UNITED STATES PATENT AND TRADEMARK OFFICE

APPLICATION NO.	FILING DATE	FIRST NAMED INVENTOR	ATTORNEY DOCKET NO.	CONFIRMATION NO.
10/519,471	12/29/2004	Helmut Mertens	47724	2683

Office Action Summary

DETAILED ACTION

Fig. 6. Modified references: C, H and R.

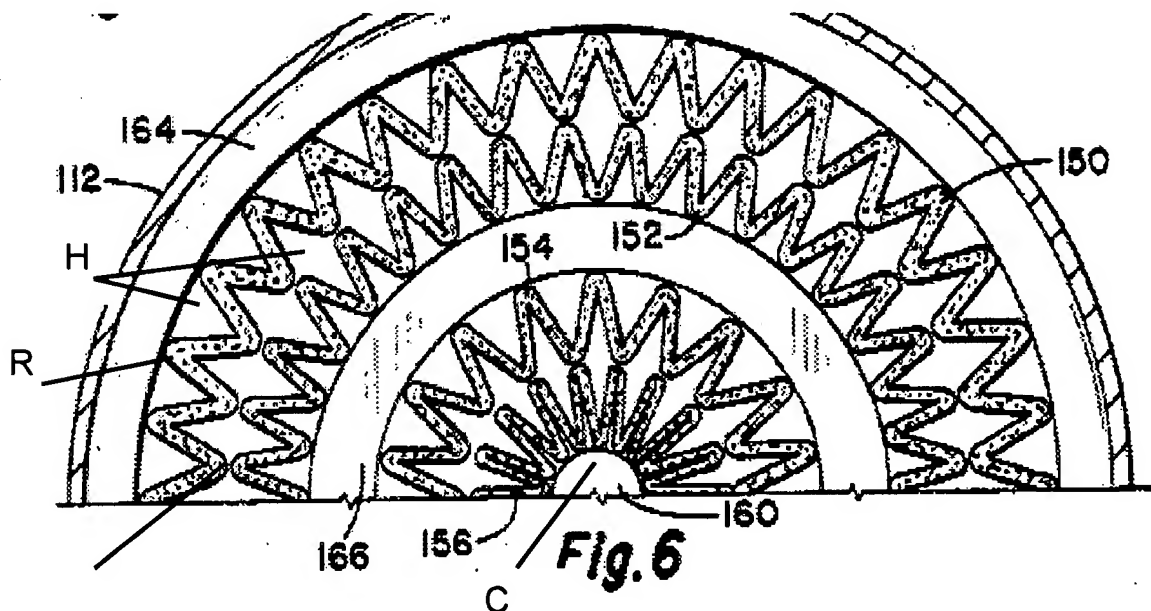
The support elements (152 and 156) are being provided on their side facing the filter unit (150 and 154) having channels (modified, Fig. 6, H) for fluid guidance.

The channels (modified Fig. 6, H) extending with their longitudinal ribs (modified Fig. 6, R) bordering by the spiral tracks (gaps of helical pleats, Fig. 1, 30 or Fig. 6, 130 and 131) along the support element (modified Fig. 6, s1 and s2),

and the channels (modified Fig. 6, H) having two free ends (along sides on Fig. 6, 114 and 116) emerging on the opposing ends of the support element (152 and 156) extending continuously without repeated deflections of the fluid stream (arrows, Figs. 1 and 5) along the support elements (152 and 156) and only partially encompass the support element (gaps of helical pleats, Fig. 6, 130, 131) with the formation of twisting guides for the fluid flow (arrows, Figs. 1 and 5).

Claim 2. Branchcomb teaches the support elements (152 and 156) being formed from a support tube (modified Fig. 6, s1 and s2 and core tube, Fig. 3, and col. 3 lines 66-67), and wherein the channels (modified Fig. 6, H) bordering laterally by the projecting longitudinal ribs (modified Fig. 6, R) of the support tube.

Clam 3. Branchcomb teaches the channels (modified Fig. 6, H) being located both on the inner and outer peripheral side on the support tube (modified Fig. 6, s1 and s2).

Clam 7. Brancomb teaches the fluid stream may flow through the innermost and the outermost filter unit (modified Fig. 6, 164 to H), from the outside (150) to the inside in the direction to the clean side of the filter element (156 and Col. 1 lines 44-49), and wherein flow is incident on the filter unit (10a, 10b and 10c), lying in between and from the two sides, to the inside and outside (modified Fig. 6, 10a to 160 or 114 to 116).

Claim 10. Branchcomb teaches 20 channels (modified Fig. 6, H) being located on one of the support elements (150) forming a common fluid guide, having a tilt of the twisting guide between 10° to 30°, preferably 15° (approximate visual angle on Fig. 1, 30 or helical pleats), relative to the axis which is parallel to the longitudinal axis of the filter element (150, 152, 154, 156 and Fig. 1 and col. 3 lines 1-4).
